Access Compliance Report

Public Rights-of-Way

(Curb Ramps)

Intersection ID: 9768	Main Street: EASTWAY_DR	Cross Street: THE_PLAZA	Location: NE
ADA ID: 7010A5E48D76	Ramp Type: PerpDiag	Initial Pass/Fail: Fail	Overall Compliance: No
Severity Score: 46.25			
Codes/Mitigation Info/Possible Solution		Field Measurements/Component Compliance

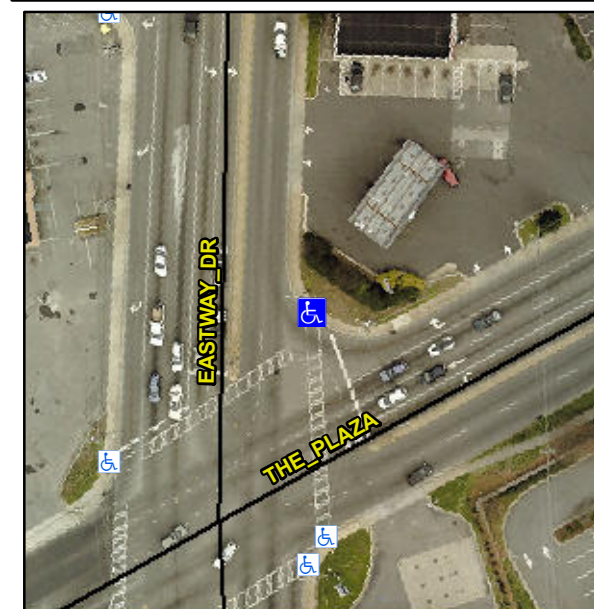
Not Found, R304.5.1, R304.2.2, R304.5.3

Compliance	Description	Data	Compliance	Description	Data
N/A	Ramp Length (in)	58.5	No	Ramp Slope (%)	9.2
No	Ramp Width (in)	37.0	No	Ramp XSlope (%)	10.4
N/A	Flare Type LT	N/A	N/A	Flare Type RT	N/A
N/A	Flare Slope LT (%)	N/A	N/A	Flare Slope RT (%)	N/A
N/A	Flare Traversable LT?	N/A	N/A	Flare Traversable RT?	N/A
N/A	Landing Length (in)	N/A	N/A	DWS Provided?	N/A
N/A	Landing Width (in)	N/A	N/A	DWS Contrast?	N/A
N/A	Landing Slope (%)	N/A	N/A	DWS Length (in)	N/A
N/A	Landing X Slope (%)	N/A	N/A	DWS Full Width?	N/A
N/A	Landing Curb? (Y/N)	N/A	N/A	DWS Offset (in)	N/A
N/A	Shared Landing?	N/A			
N/A	Gutter Ponding?	N/A	N/A	Gutter Slope (%)	N/A
N/A	Gutter Lip Ht (in)	N/A	N/A	Gutter X Slope (%)	N/A
N/A	Painted X Walk1?	Yes	N/A	Painted X Walk2?	Yes
	X Walk 1 Direction	To SW		X Walk 2 Direction	To S
N/A	X Walk 1 Width (in)	73.0	N/A	X Walk 2 Width (in)	77.0
	X Walk 1 Slope (%)	6.5		X Walk 2 Slope (%)	2.0
	X Walk 1 X Slope (%)	2.7		X Walk 2 X Slope (%)	6.5

Remove & Replace Curb Ramp With Two New Directional Ramps or Equivalent.
